# TECHNICAL INFORMATION

63291

**Subject** ▶ Change on the Way to Attach Sleeve to Skirt

**For Models** ▶ BO6040

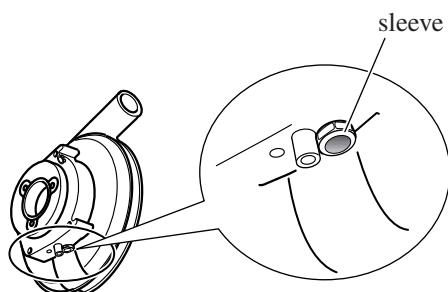
▶ **Current**

The sleeve is machine-pressed into Skirt Complete.  
Adhesive is not used.

▶ **New**

First, Adhesive is put on Sleeve.  
And then, the sleeve is machine-pressed into Skirt.

| Item No. | Current part               |  | Q'ty | I/C | New part                   |  | Q'ty | Note |
|----------|----------------------------|--|------|-----|----------------------------|--|------|------|
| 020      | Skirt Complete<br>152795-2 |  | 1    | ←   | Skirt Complete<br>152948-3 |  | 1    |      |
